## DESIGN REVIEW BOARD RECOMMENDATION MEETING

2ND + STEWART | 1613 2ND AVENUE

DPD# 3025998 January 17, 2017

## MAJOR MUP REVISION RESPONSE

Approved DRB: 9/29/2015

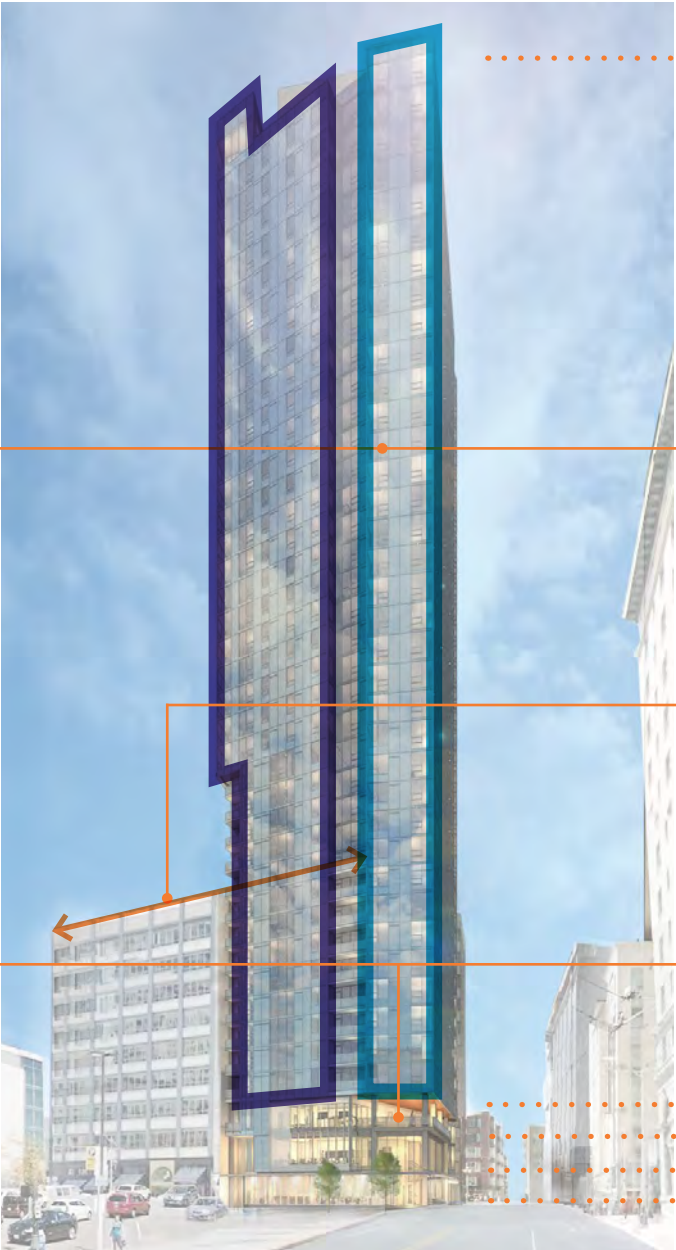
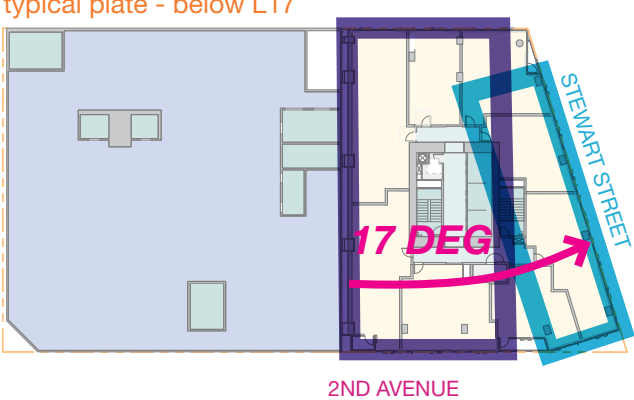
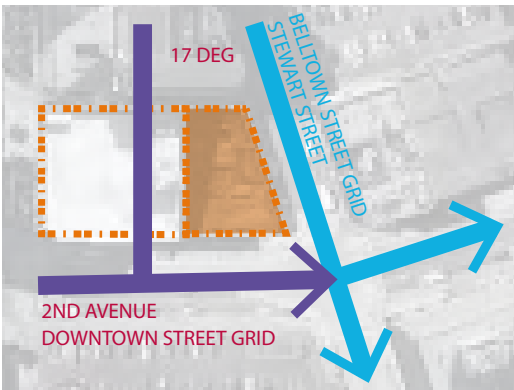
02/04/15 MUP Decision / Board

**Direction:**  
"The Board congratulated the design team on significant improvements to the project. The shaft of the building was deemed elegant and smart."

In order to maintain the approved concept of the tower massing, two conditions are proposed. First, a retention a concept of a "cant and shift" of the street grid being reflected in the massing needs to be maintained. Secondly, the massing of the tower should enhance the aspect ratio (height to width) inherent in the geometry of the site.

Amenity Roof Top L39:  
09/29/15 configuration

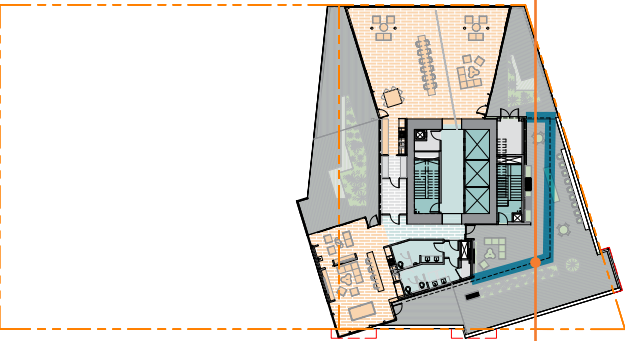
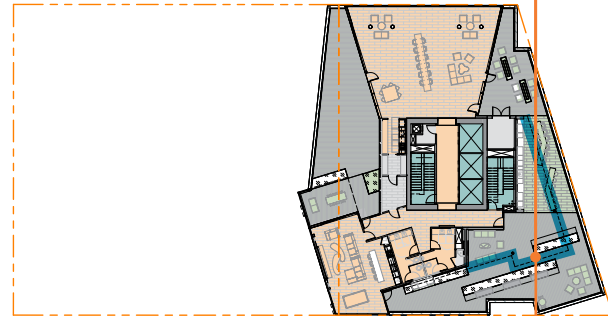
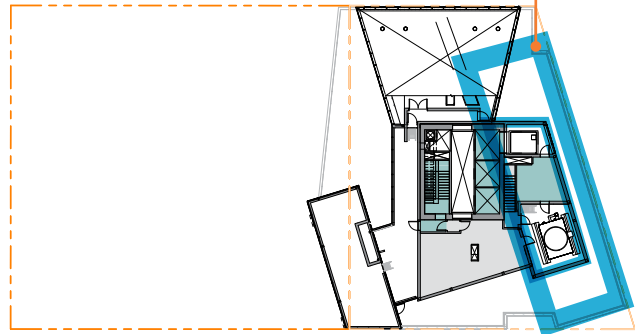
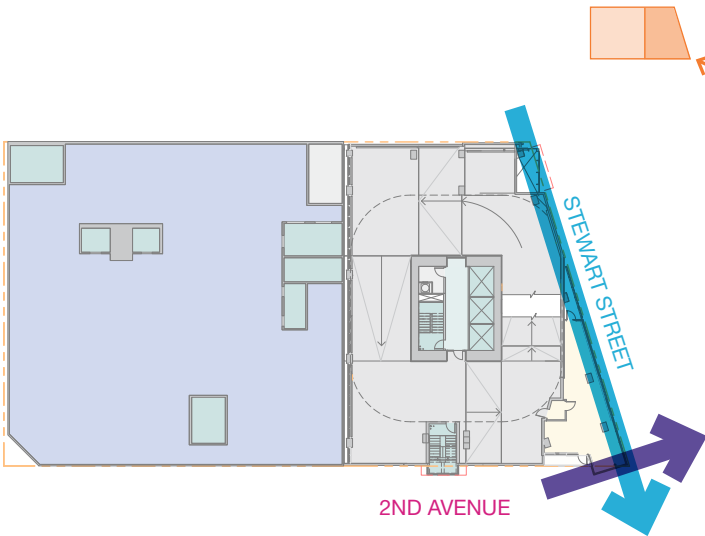
**02/04/15 MUP Decision / Board Direction:**  
"The Board encouraged further study and refinement of the rooftop design; p.15"

"There was a positive response to the unusual rooftop configuration, but the Board would like to see further details, and from a variety of perspectives, how it caps the building."

**A-2 Enhance the Skyline**  
covered area created by L40 mech level above refined to better relate to the massing of the tower than the approved 09/29/16 version

**MUP Revision Response:**  
L40 rooftop configuration at Final Recommendation meeting as shown on the left was further refined to meet the direction given by the Board at the REC and was included in the approved MUP. Current proposal reflects the configuration of the final approved MUP 02/04/2016. Notable refinements is the massing housing mechanical equipment

Approved DRB: 9/29/2015

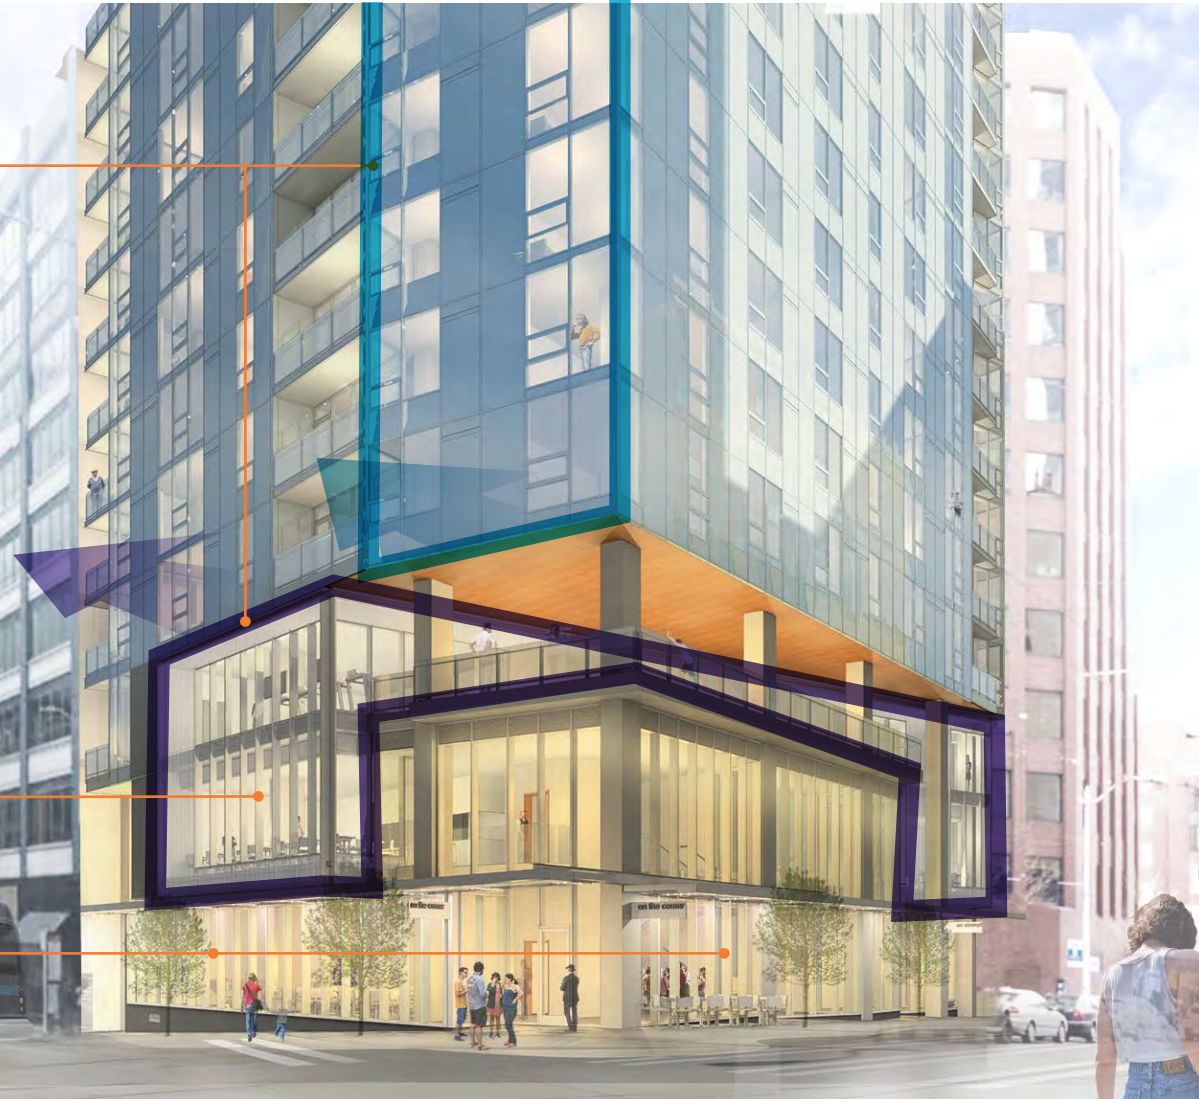
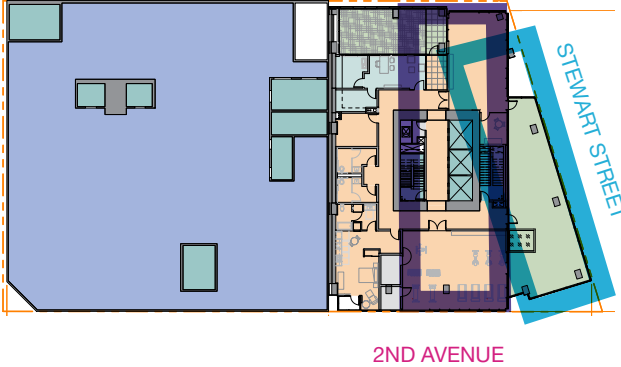
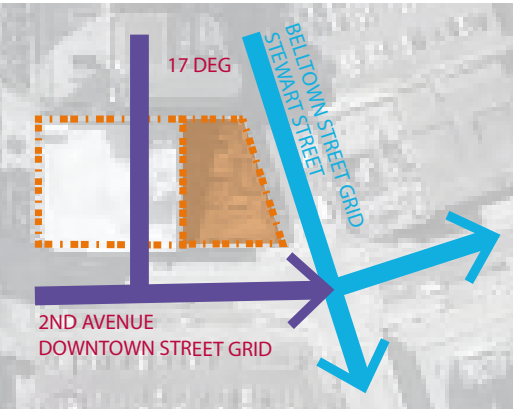
The Board encouraged the design team to continue an exploration of whether the overall design might not be strengthened without the introduction of new materials and color for the proposed screening/cladding of the above grade parking along 2nd Avenue.

Proposed - no above grade parking; 2 levels of retail uses; residential amenity above on L03 expressed as a "glass box"

Response: a unified "glass box" running diagonally through levels 2 and 3 replace the Swiss pearl wrapping of the above grade parking at Stewart St and white precast on Second Ave.

Approved DRB: 9/29/2015

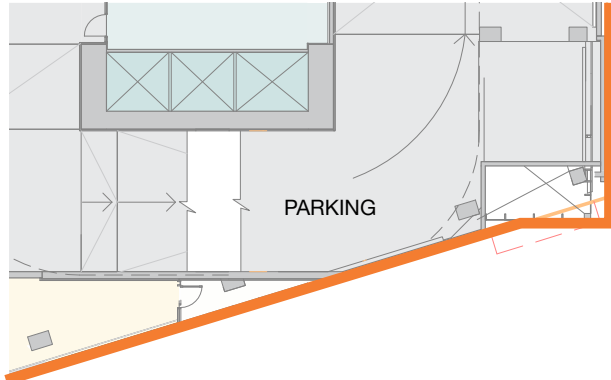
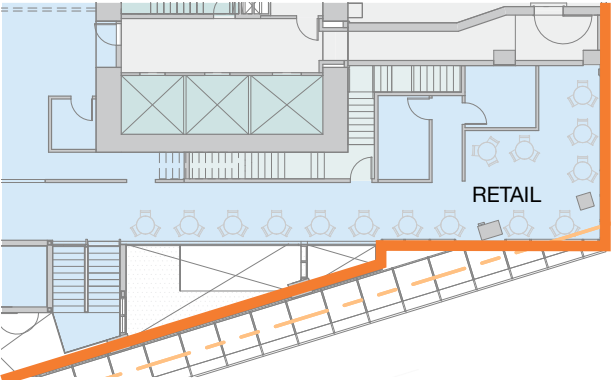
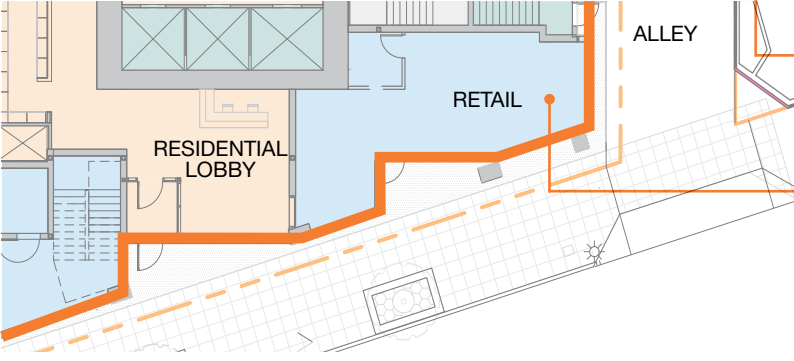
09/29/15 Board's Deliberations:

The simplification of the base form and the re-articulation of the northwest corner were deft moves, as was the continuation of the golden Swisspearl cladding from the outside to the inside to encapsulate the parking ramp structure as it protruded into the double-height interior retail and lobby space.

Proposed major MUP revision relocates the residential entry to Stewart Street allowing for an increased, continuous retail frontage on Second Ave. On level 03, residential amenity uses - fitness and an outdoor terrace "extend" an activated facade beyond the edges of the business day

The garage entry adjacent to Stewart Street has been eliminated. Garage entry is now located at the south end of proposed structure. Retail uses wrap the corner at the alley the "encapsulated" parking ramp as an object slicing through the lower levels is replaced with a translucent "box" containing active retail and residential uses.

Approved DRB: 9/29/2015 .....

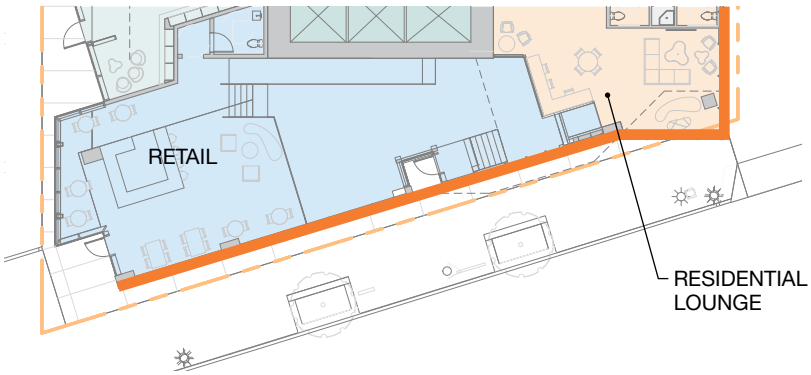
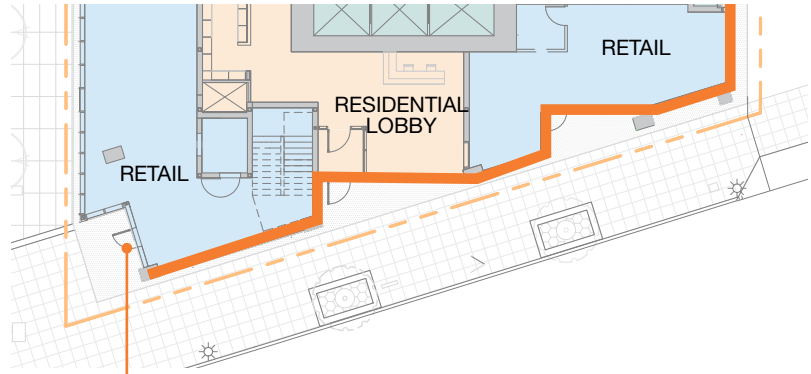
09/29/15 Board's Deliberations:

Demonstrate to the Board how the turning radii in and out of the parking openings would work safely and effectively; The Board recommended that the design team work further with neighbors in the ally, and further refine and to address vehicular safety concerns;

Response:

The garage entry adjacent to Stewart Street has been eliminated. Garage entry is now located at the south end of proposed structure. Retail uses wrap the corner at the alley

Proposed Major MUP revision design reinterprets the parking wrapper as a "glass box" containing retail and residential uses are expressed in the interior and exterior
